**Troy School District**

# **Bond Projects BP#32**

**PROJECT MANUAL**

**Issued: January 20, 2021**

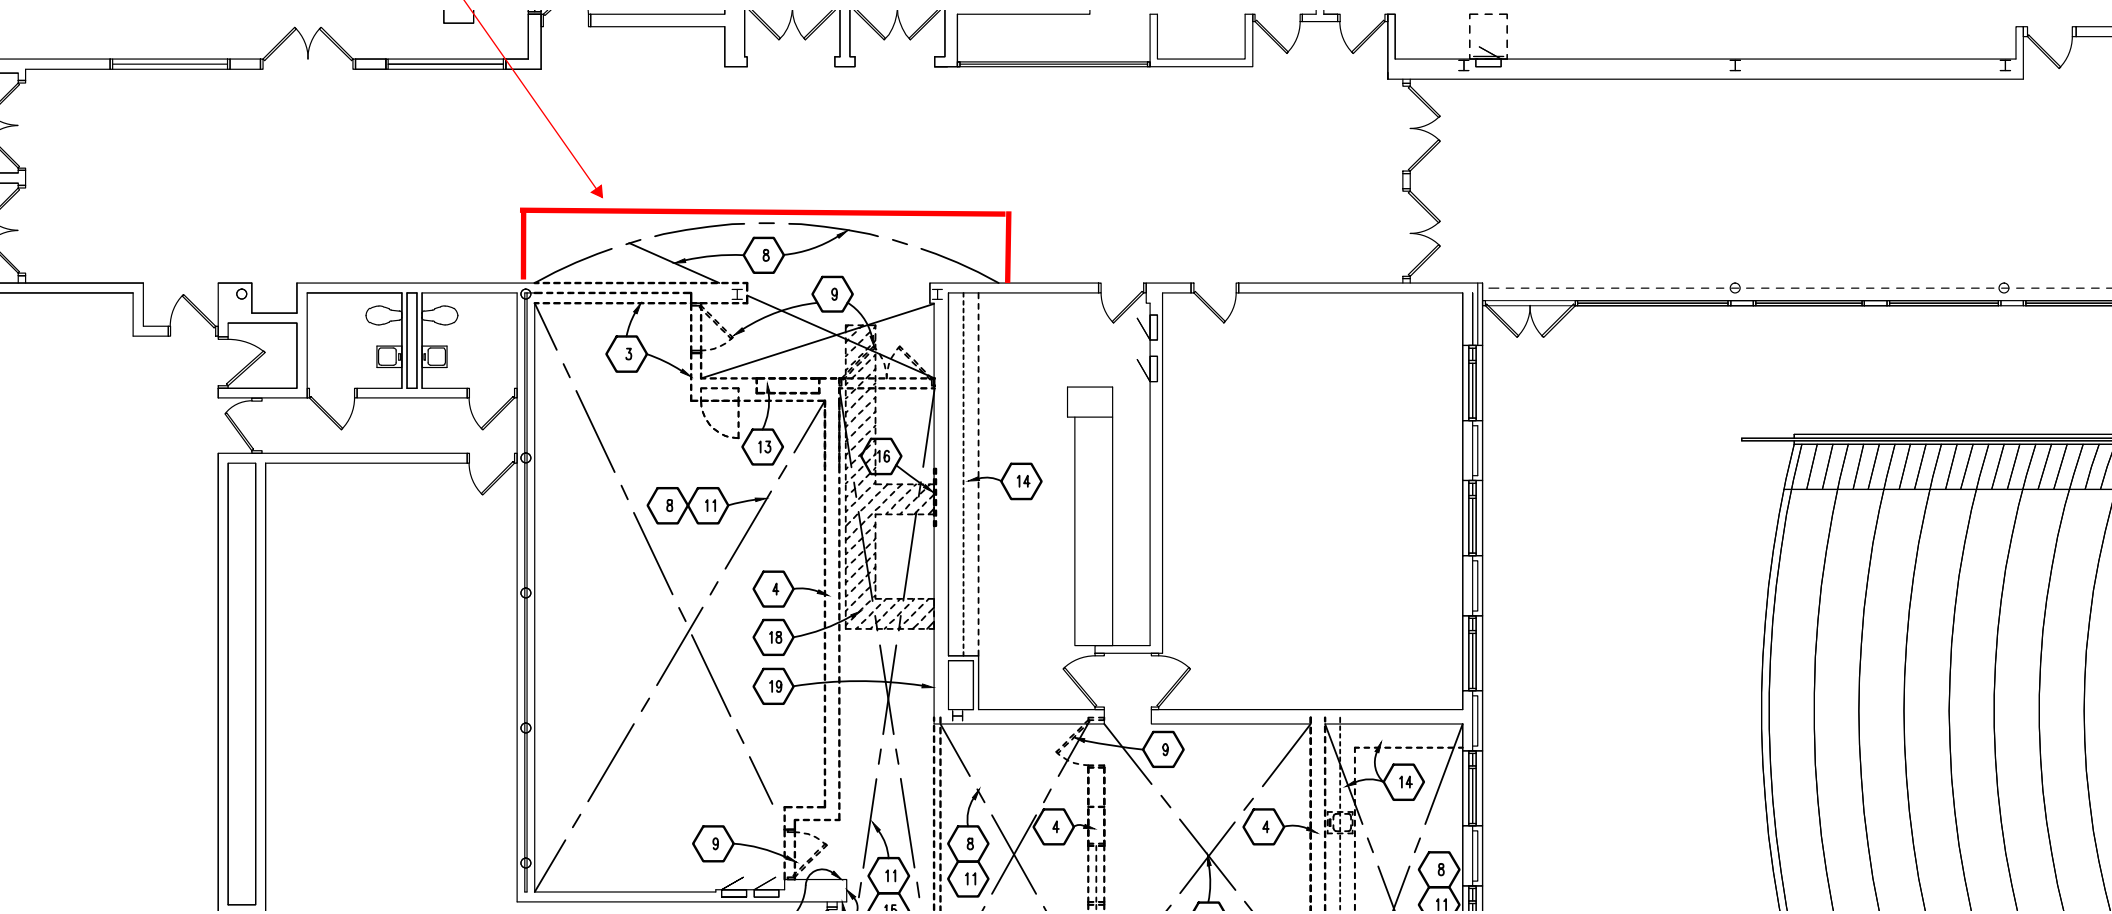
**Q:** Smith Middle P127 door frame is the throat deep enough to cover sides at opening

**A:** This is not the intent. Masonry to be toothed-in at jambs
